**ONSITE SEWAGE DISPOSAL SYSTEM**

**Tank  
Replacement**

PROPERTY ADDRESS: 11706 Wayneridge Court

**From:** Oswald Jr, Woodin  
**Sent:** Wednesday, February 25, 2026 7:58 AM  
**To:** Debbie VanSant  
**Cc:** Silvast, Zackary  
**Subject:** Perc Cert Plan Review Comments\_11706 Wayneridge Court  
**Attachments:** 11706 Wayneridge Ct Approved.pdf

**SITE PLAN**  
SCALE: 1"=40'-0"

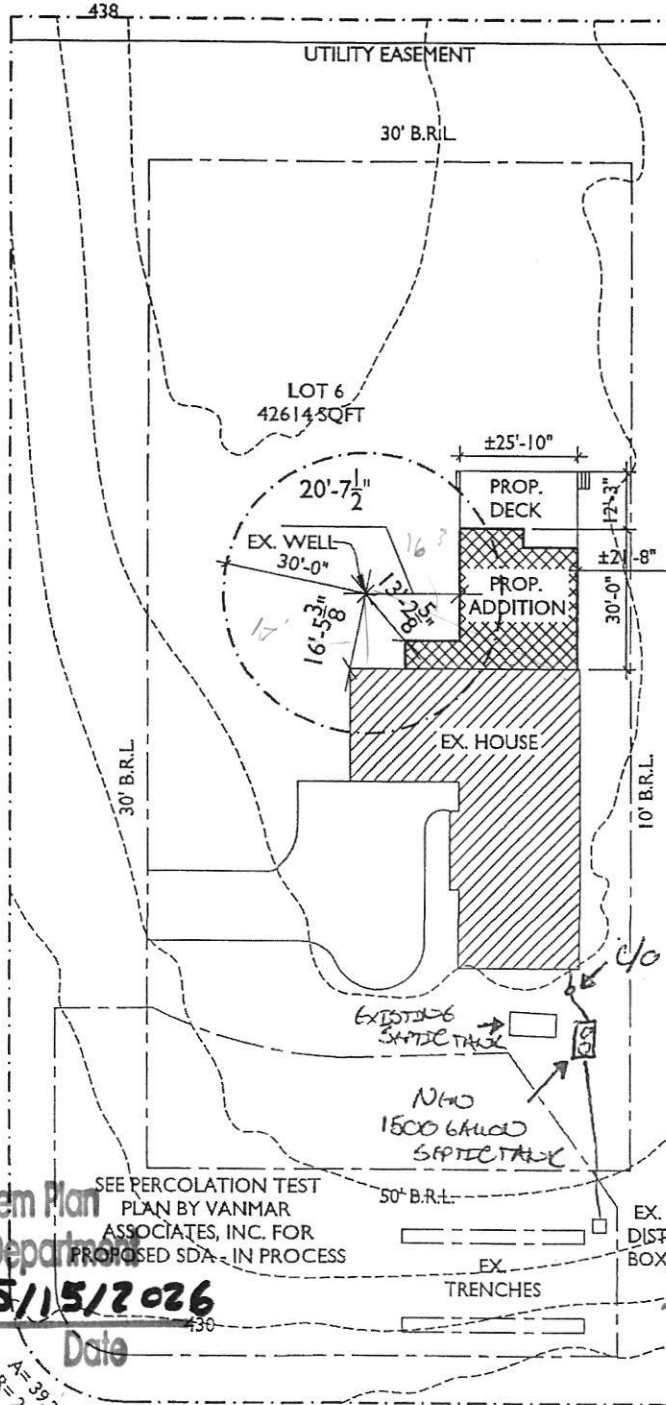
septic is existing  
drainfields good for 4 BRs

\*\*\* For their addition, they will need to upgrade their septic tank. \*\*\*  
- will need an OS DS for that.  
yld 4/16/26

- Replace line from house to tank to include a c/o near home. Line to have 2% fall and be composed of 4" SCH 40 PVC
- Existing tank to be pumped crushed, and abandoned
- Install new 1500 gallon, 2 compartment top seam septic tank
- all risers to be 6" above grade and new tank to have no more than 3' of cover
